DOWNTOWN REVIEW BOARD
MEETING AGENDA

WEDNESDAY, May 6, 2015
8:30 A.M.

FILE NO.:
CPC NV 15-00030 – QUASI-JUDICIAL

PROJECT: **RED MARTINI SIGNAGE**

FIGURE 4

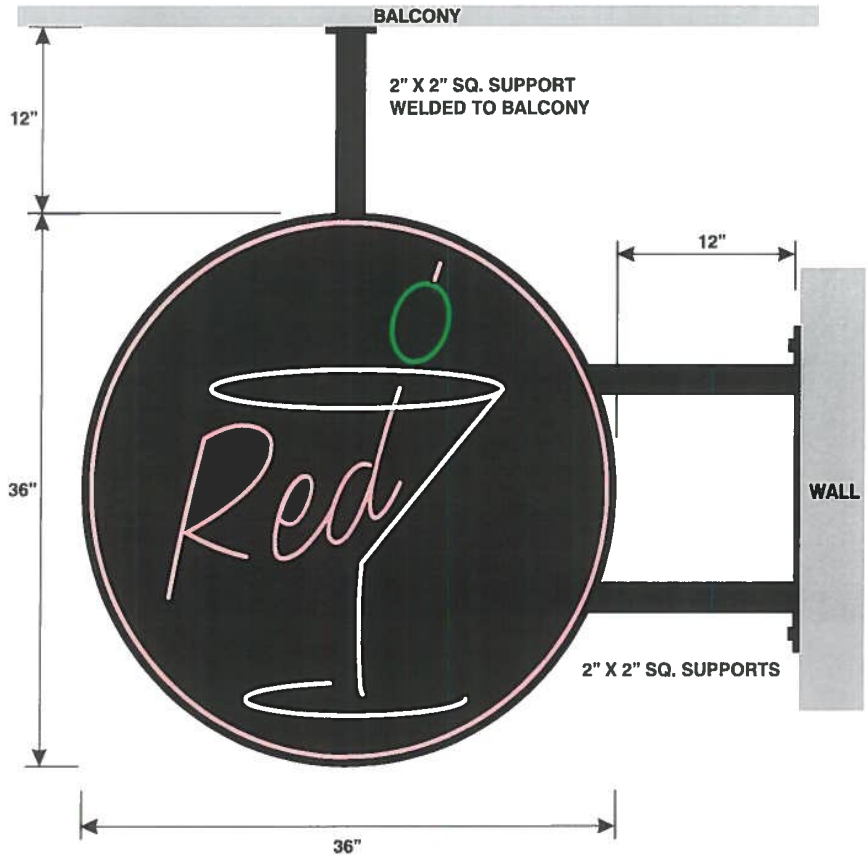
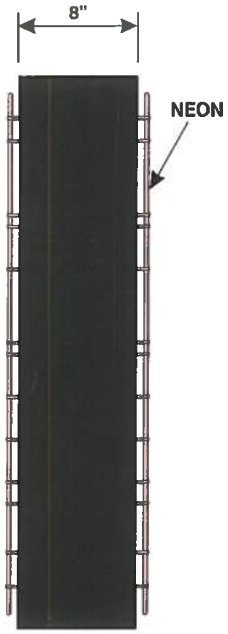
The proposed sign complies with at least 7 of the 8 guidelines. The only one that is unclear is the guideline describing a minimum vertical clearance of 11 feet – the plan doesn't label the vertical clearance, but it is likely less than 11 feet.

1. Add the file number to the bottom corner of the plans.
2. Add a note that all unpermitted banners must be removed prior to installation of the proposed sign.
3. Label the minimum vertical clearance of the proposed sign.
4. Modify the site plan to clarify the sign's location relative to the existing balcony and sides of the existing business.
5. Add a note to the plan identifying the site as being zoned FBZ-CEN.

1 DEVELOPMENT & SITE PLAN

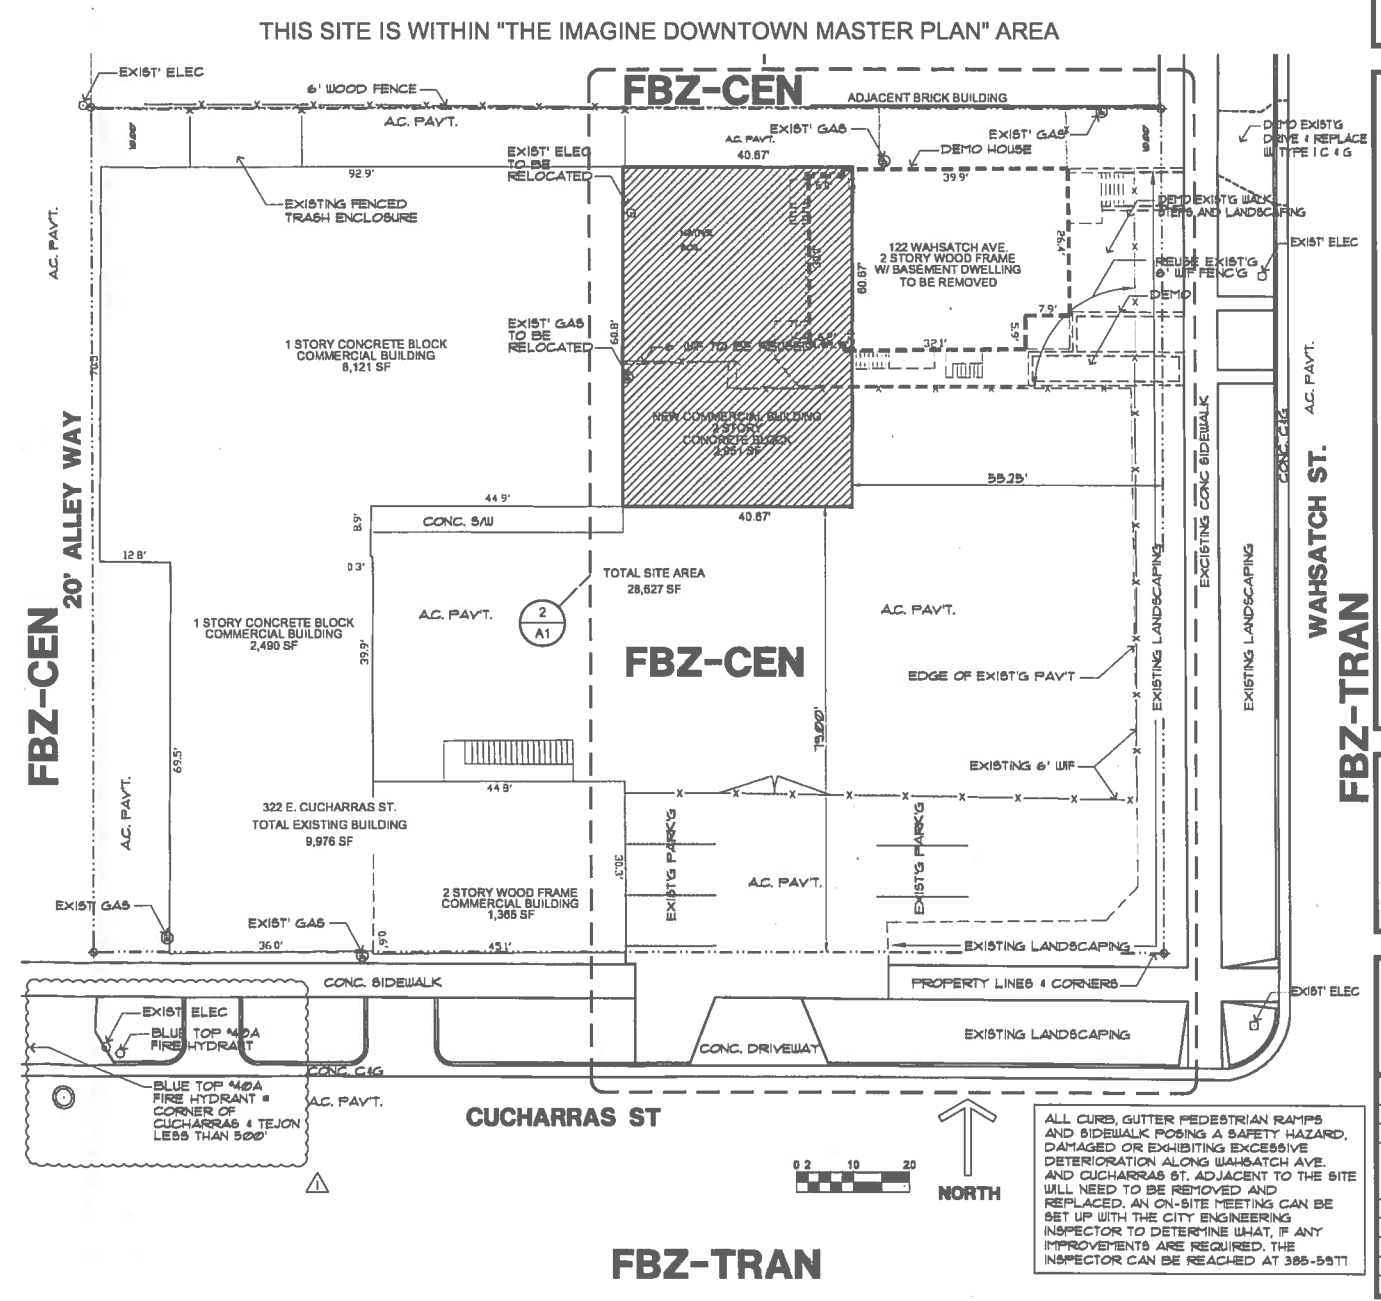
Although many of these goals and principals were discussed prior to the submittal of the application, the initial plans were deficient on numerous issues. The proposed addition was one-story and had very little glazing along its front façade. Although some landscaping and fencing were proposed along S. Wahsatch Ave., the design was more suburban than urban. Staff's review letter critiquing the initial submittal, as well as the stakeholder comments which were forwarded to the property owner and applicant, communicated significant design issues which made support of the project difficult.

Recognizing the goals, objectives, and standards of the FBZ, the applicant and owner worked with Planning Staff to revise the development plan to more closely align with the FBZ standards (**FIGURE 6**). A second story was added to the addition to provide more bulk and mass and to allow mixed office/commercial use opportunities; glazing was increased along the east-facing façade; a four foot high stucco and metal wall replaced the wrought iron fence to help screen parking and stored vehicles; and public space improvements were added to improve pedestrian character.

While significant improvement was made with the revised plan, three form-based warrants are still necessary. As a two-story building, the structure is now considered a "mixed use" building which is a permitted building type in the Central Sector. However, a mixed use building is required to be located adjacent to the public right-of-way with a zero foot front setback. While the proposed two-story building adds much needed bulk and scale to the area, the proposed 55.25 foot front setback along S. Wahsatch is far greater than required by code. Additionally, the FBZ requires that mixed use buildings utilize either a storefront or gallery frontage type, both of which require 60% glazing due to their proximity to the sidewalk. The proposed building addition utilizes a common lawn frontage type, largely due to the building's physical setback. And while mixed use buildings aren't permitted to have a common lawn frontage, it is noteworthy that the minimum glazing requirement of a common lawn frontage (25%) is met with the revised building design.

The third warrant that is required is to allow the improvement of the S. Wahsatch Ave. right-of-way using the "wide" amenity zone design option, which is normally only allowed in the FBZ's transition sectors; Central Sector properties are required to use either the "planter" or "narrow" amenity zone design options. The wide amenity zone design utilizes a roughly eight foot wide planter (i.e. tree-lawn) area whereas the other two amenity zone options use either tree grates or a six foot wide planter design. The proposed amenity zone design is reasonable in this instance as the proposed improvements are simply extending the existing streetscape northward roughly 40 feet.

1. Correct the scale bar and produce the site plan at a standardized scale.
2. Correct the plan to list the proposed addition as a “mixed use” building.
3. Clarify the existing lot coverage (with the house demolished) and the proposed lot coverage once the addition is built.
4. Modify the warrant note on sheet 1 to correctly list the warrants as described above.
5. Adjust the site plan to provide consistency with the wall, bench and landscape improvements shown along S. Wahsatch Ave. on the landscape sheet.
6. Provide a building elevation for the north facing façade.
7. Provide the recorded documents for the northern “right-of-way” to verify that placing structures (e.g. trash enclosure) is acceptable.
8. Unless it has been vacated, the northern “right-of-way” should be illustrated on the development plan.

WAHSATCH ELEVATION

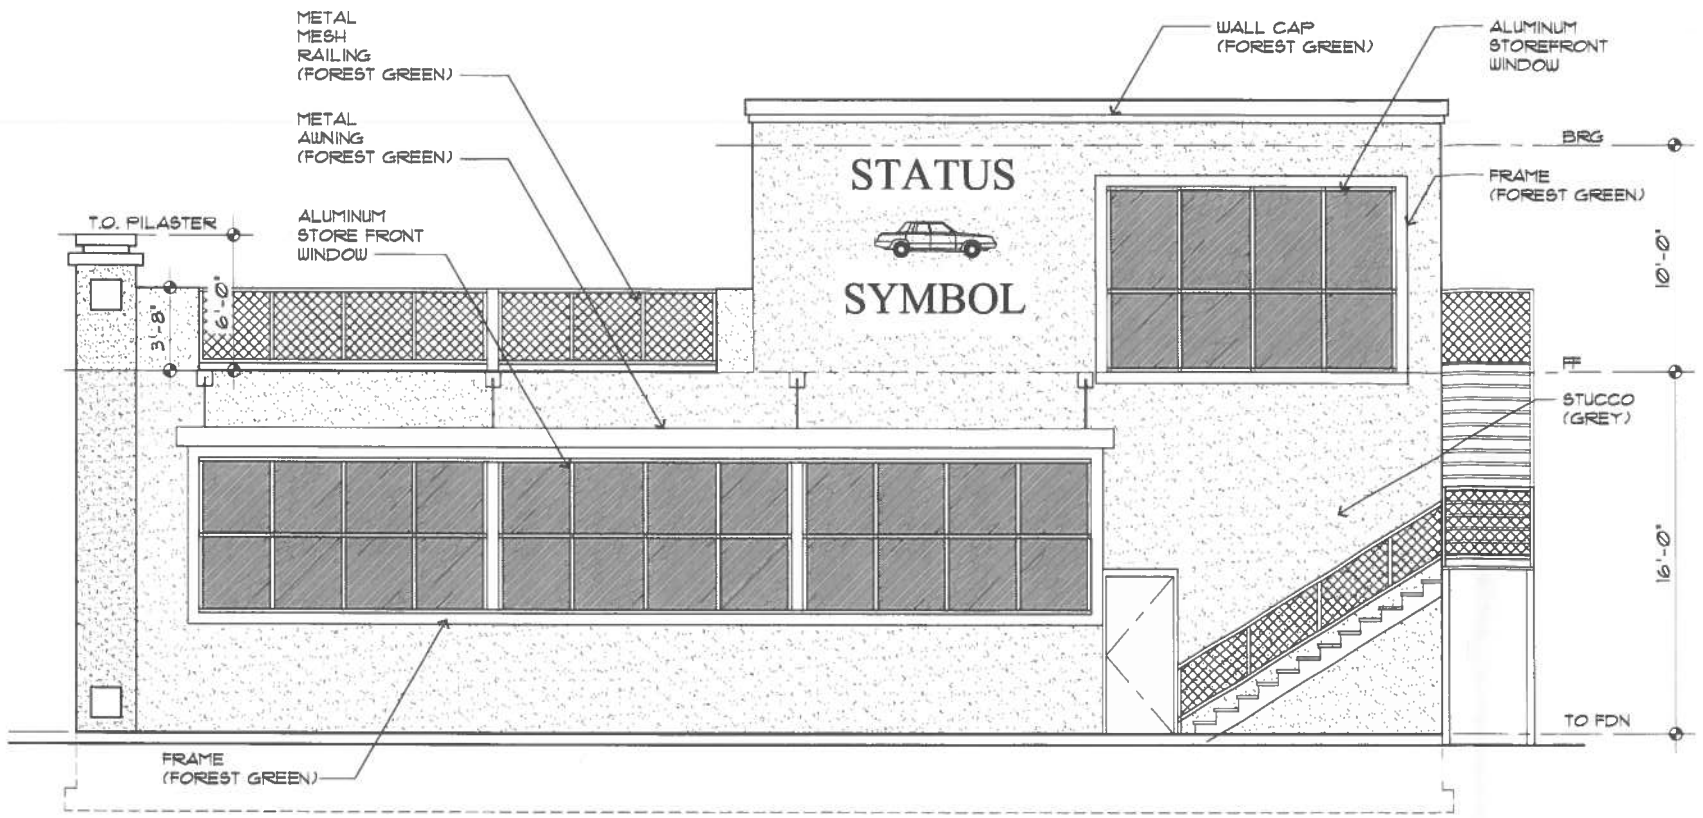
TOTAL WALL AREA:
1,306 SF
GLAZING AREA:
376 SF = 28.8% OF WALL AREA
